HIGH PLAINS FILING NO. 1

CONSTRUCTION DOCUMENTS

SP-18-003
SF-18-024

HIGH PLAINS FILING NO. 1
GRADING & EROSION CONTROL PLAN

SITE MAP
SCALE: N.T.S.

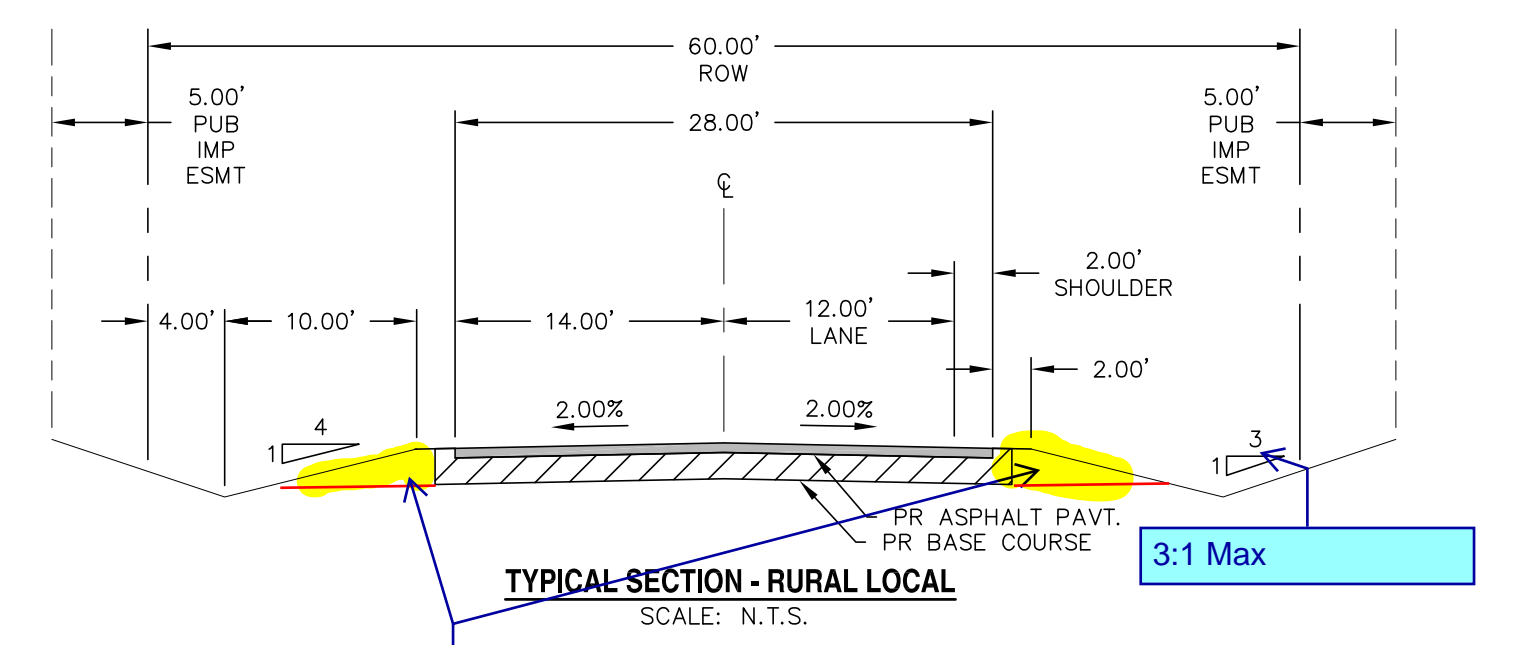
Revise the extents of the aggregate base course per the standard detail.

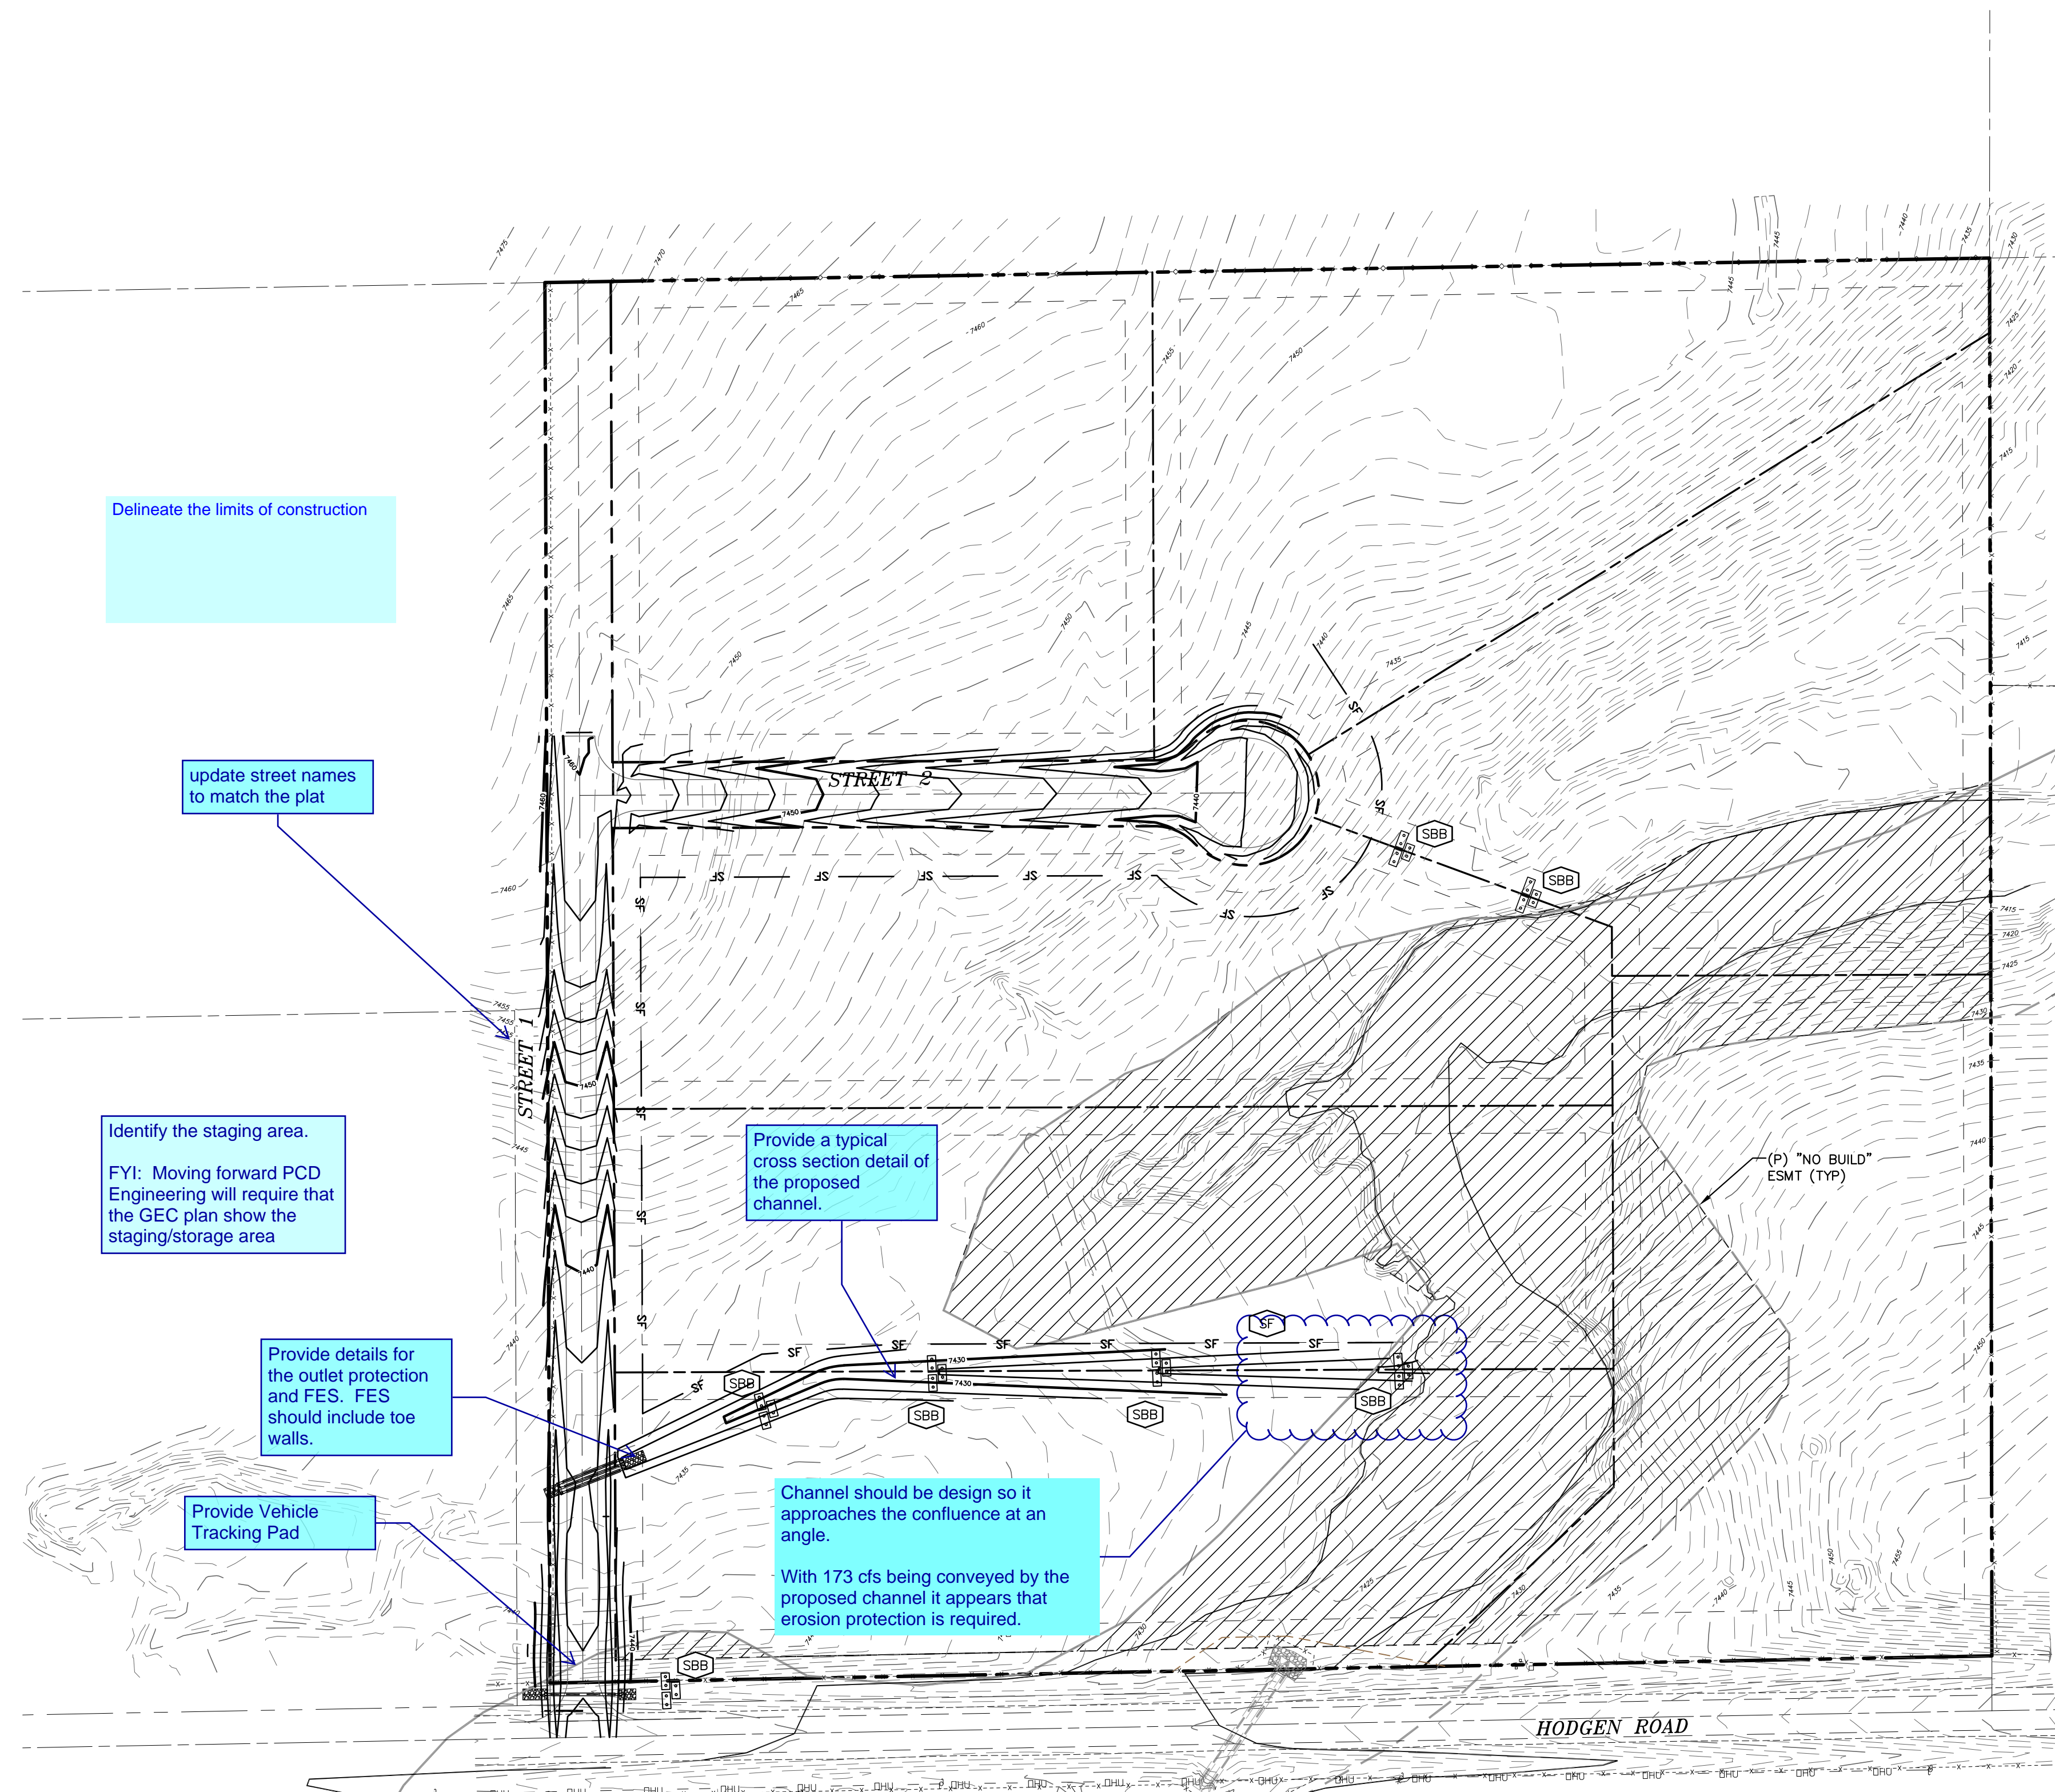
Delineate the limits of construction

update street names to match the plat

Identify the staging area.
FYI: Moving forward PCD Engineering will require that the GEC plan show the staging/storage area

Provide a typical cross section detail of the proposed channel.

Provide details for the outlet protection and FES. FES should include toe walls.

Provide Vehicle Tracking Pad

Channel should be design so it approaches the confluence at an angle.
With 173 cfs being conveyed by the proposed channel it appears that erosion protection is required.

HIGH PLAINS FILING NO. 1
RIDGEBACK ROAD
STREET IMPROVEMENT
PLAN & PROFILE

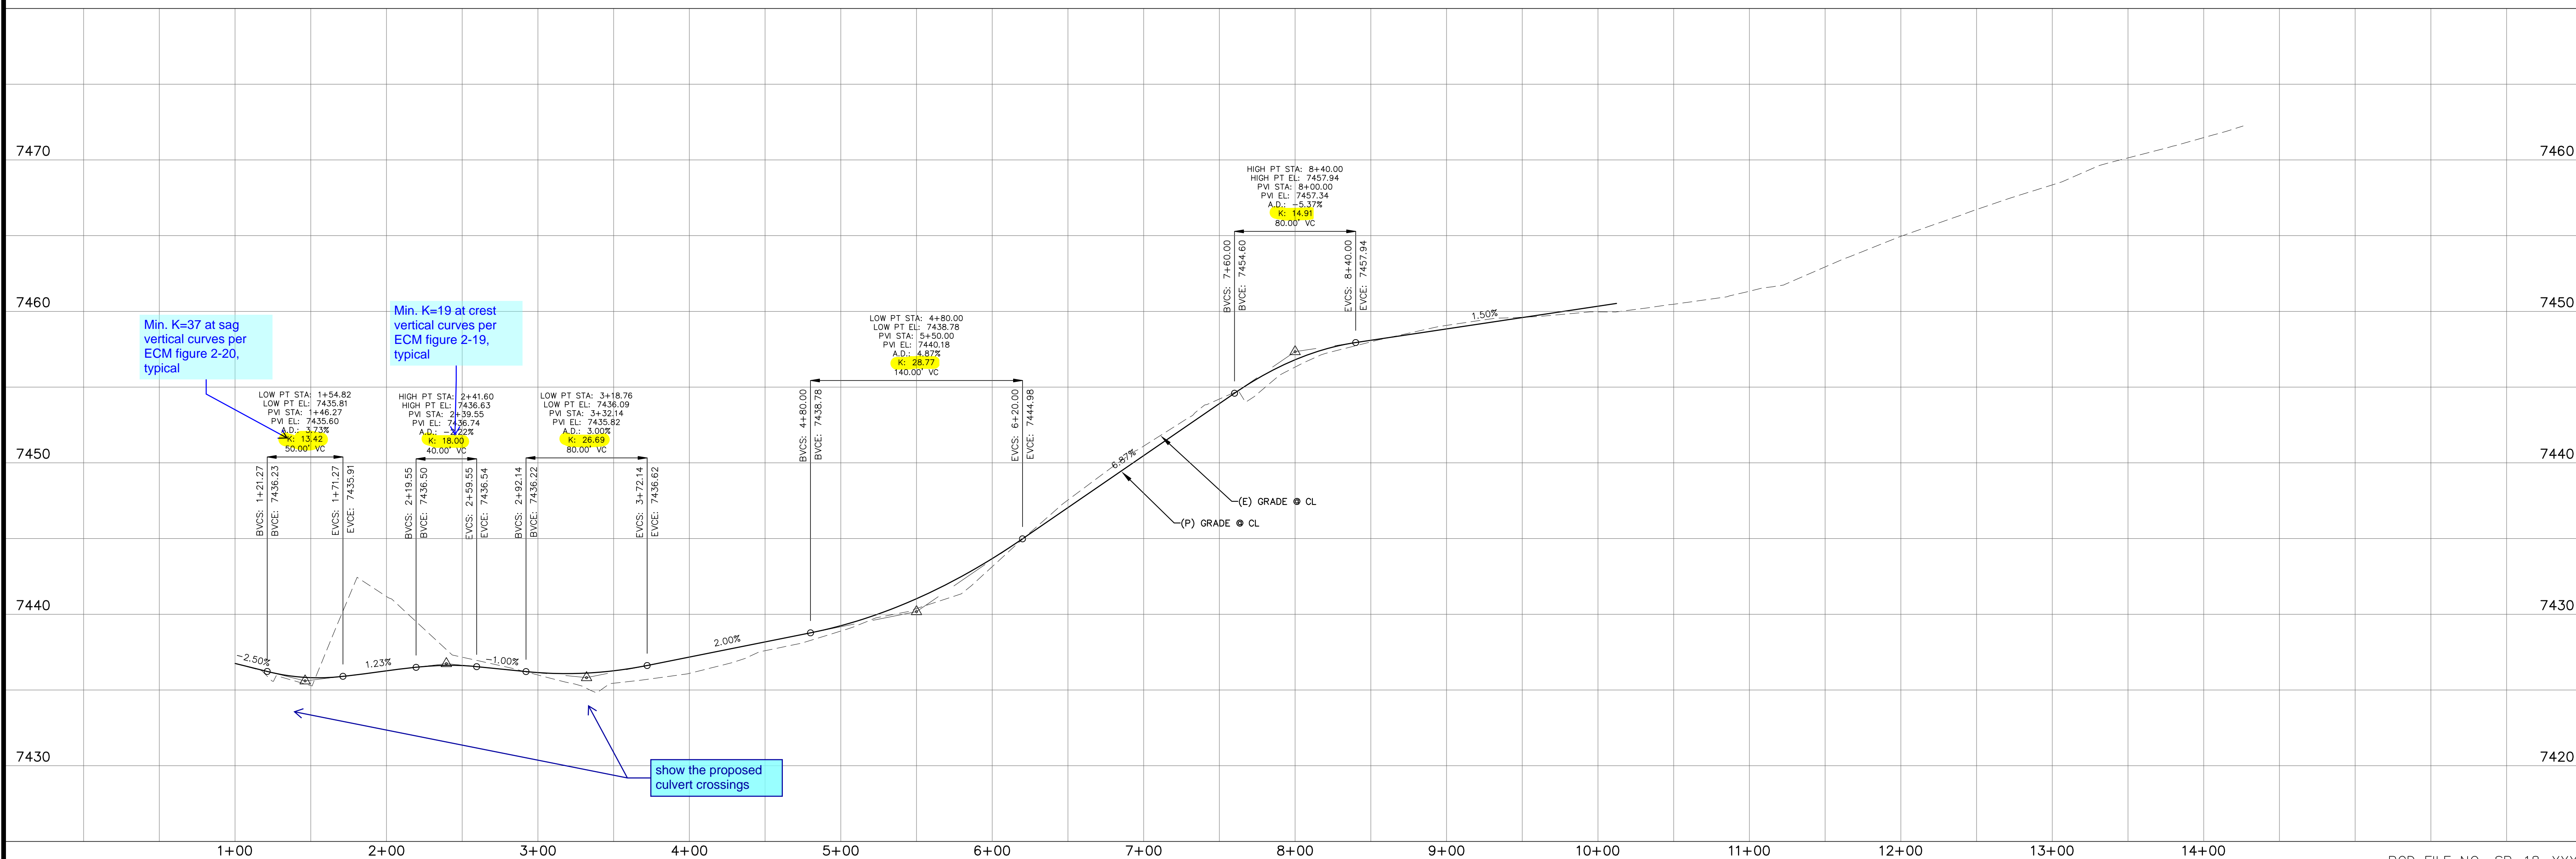
Storm Pipe P&P is missing.

Install a temporary barricade

Indicate road classification and provide road names per final plat

Min. K=19 at crest vertical curves per ECM figure 2-19, typical

Min. K=37 at sag vertical curves per ECM figure 2-20, typical

HIGH PLAINS FILING NO. 1
RALEIGH ROAD
STREET IMPROVEMENT
PLAN & PROFILE

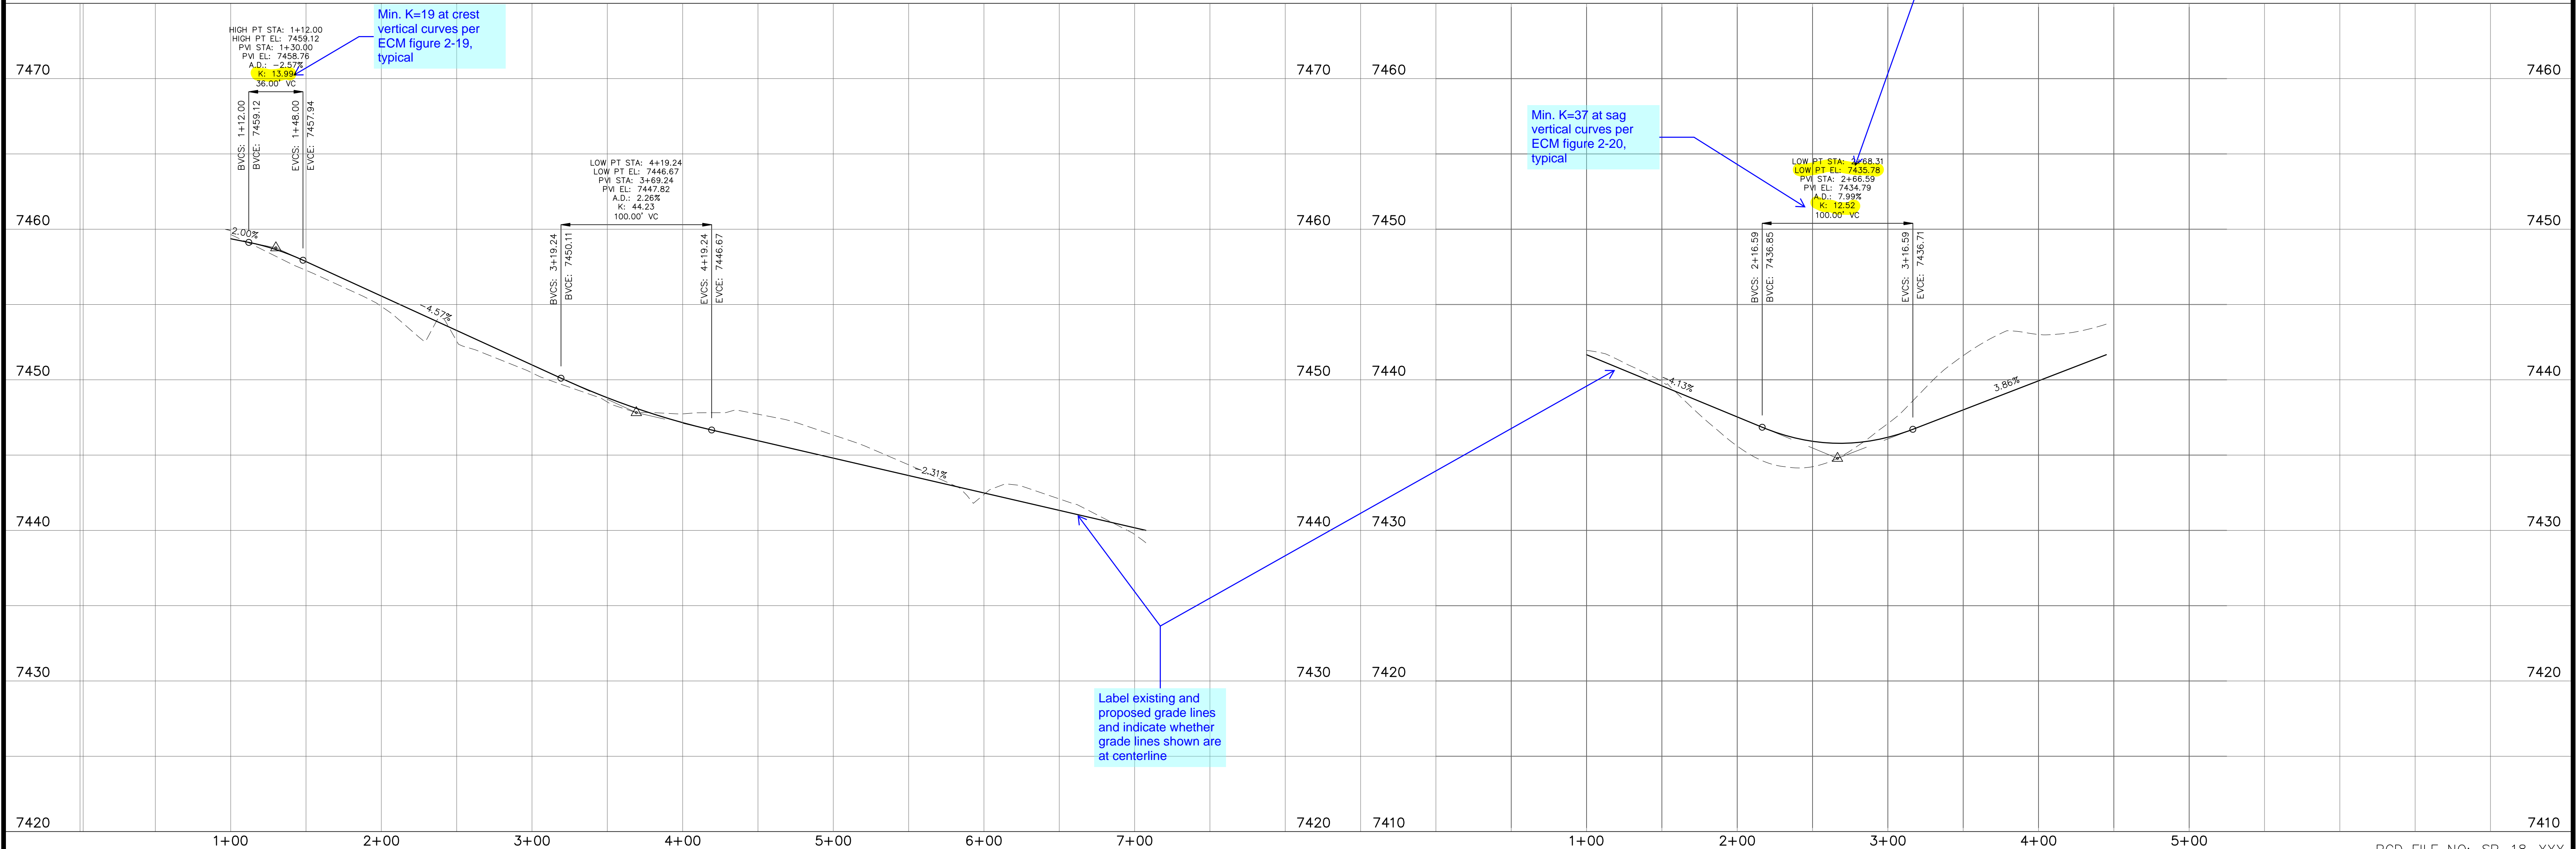
Adjust cul-de-sac grade for a max 2% slope per ECM figure 2-31. As shown there is a ±8% grade from center of cul-de-sac to low point.

Label existing and proposed grade lines and indicate whether grade lines shown are at centerline
